RE: MDP 856 Wind Gate @ Kallison Ranch

Re: **Wind Gate @ Kallison Ranch**

MDP # 856

WIND GATE AT KALLISON RANCH

WIND GATE AT KALLISON RANCH
MASTER DEVELOPMENT PLAN

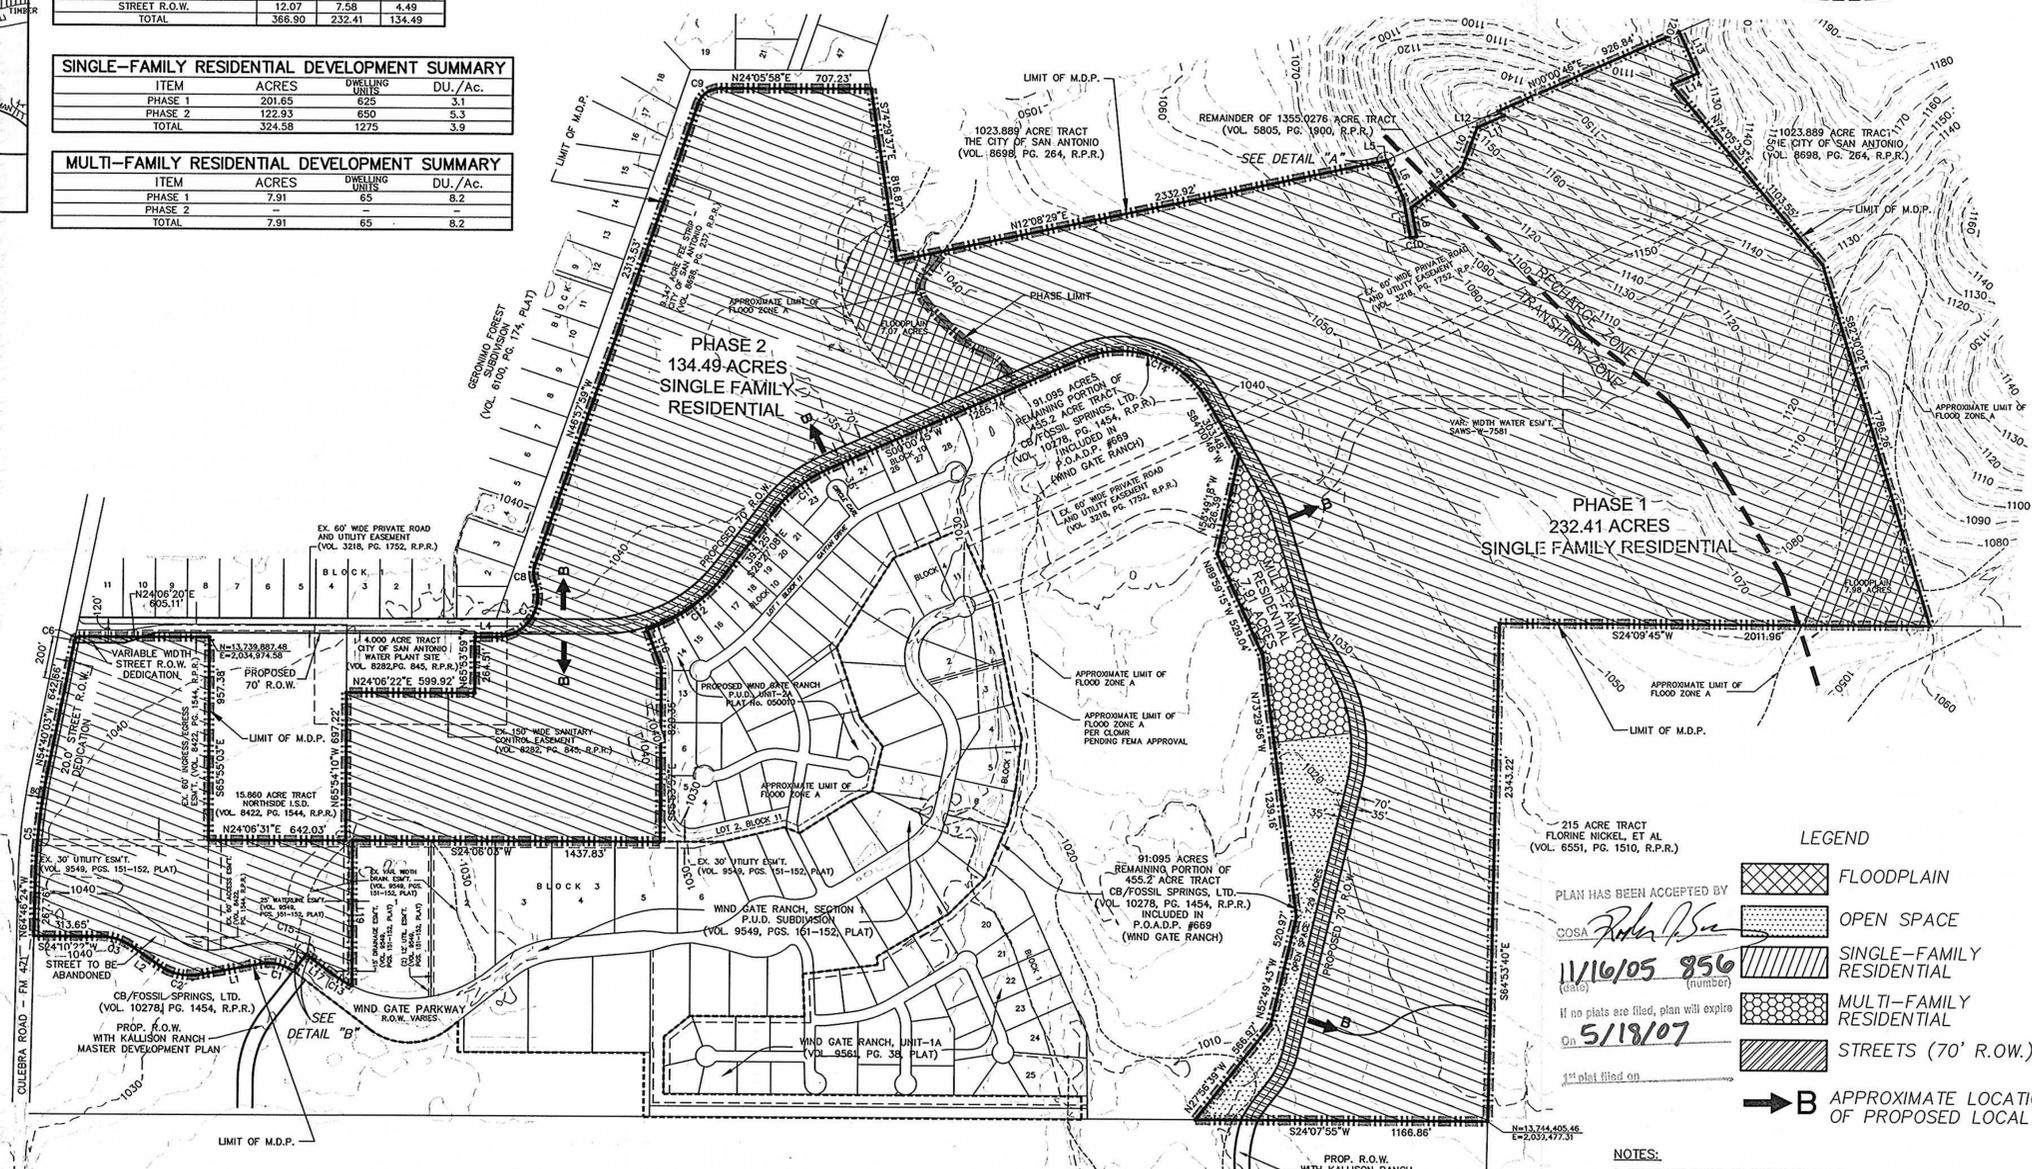
- In consideration of public safety and convenience, excessive grades by reason of topography should be avoided in street layouts and arrangements.
- Any access and R.O.W. issues along state facilities will need to be resolved with the **Texas Department of Transportation (TXDOT)**. For information about these requirements you can contact TXDOT at 615-5814.
- **SAWS Aquifer Protection and Evaluation** will require, pursuant to the Aquifer Protection Ordinance No. 81491, the following items for Plat Certification:
 1. 100 year Flood Plain Shown and Buffering (if applicable)
 2. Sensitive Recharge Features and Buffering (if applicable)
 3. Category Letter for All Site Specific Plats (if Category 2 or 3, an Aquifer Protection Plan is required)

- The staff Archaeologist has reviewed the Master Development Plan and recommends that the project area be inventoried before moving the project forward. The analysis has revealed a high probability that cultural and archaeologically significant resources exist on the site.

- Amended TIA for individual units required at platting for traffic movements at internal intersections at proposed collector.
- Construct collector width (70' of Right-of-way and 44' of pavement) roadway through the development. Collector to be widened at internal intersections to 86 feet to accommodate separate left-turn bays lanes with required vehicle storage and bay taper **if required** by amended TIA traffic counts.

- Construct a eastbound left-turn lane on Culebra Road and a westbound right-turn deceleration lane with required storage and bay taper lengths as it relates to the submitted TIA traffic counts and TxDOT requirements, (Uniform Development Code (UDC) - 35-502 (a)(7), subsection C, at the intersection of Culebra Road and the proposed collector street entrance to the subdivision.

- Construct a southbound right-turn lane with required storage and bay taper as it relates to the submitted TIA traffic counts, (Uniform Development Code (UDC) - 35-502 (a)(7), subsection C, at the intersection of Culebra Road and the proposed collector street entrance to the subdivision.

- The developer shall install a traffic signal (when warranted and approved Bexar County and TxDOT) at the proposed collector and Culebra Road intersection.

- All Roadways shall conform to UDC 35-506 (c), (1), Table 506-1: Functional Classification System Description.
- Provide clear sight distance at each roadway to provide adequate distance for obstruction free viewing distances for approaching traffic. All signage, landscaping and improvements should be selected and located so as to not block these clear sight distance areas.
- **It should be understood that the submitted TIA concurrent with the proposed Wind Gate at Kallison Ranch MDP is a conceptual plan and therefore this document does not represent an approval for the internal street plan.** All streets shall follow UDC 35-506 and the street network shall be planned in order to provide safe and efficient movement of traffic to and from, within and past, the proposed development, while minimizing the impact to non-site trips. UDC 35-506 will be implemented at the time of platting.
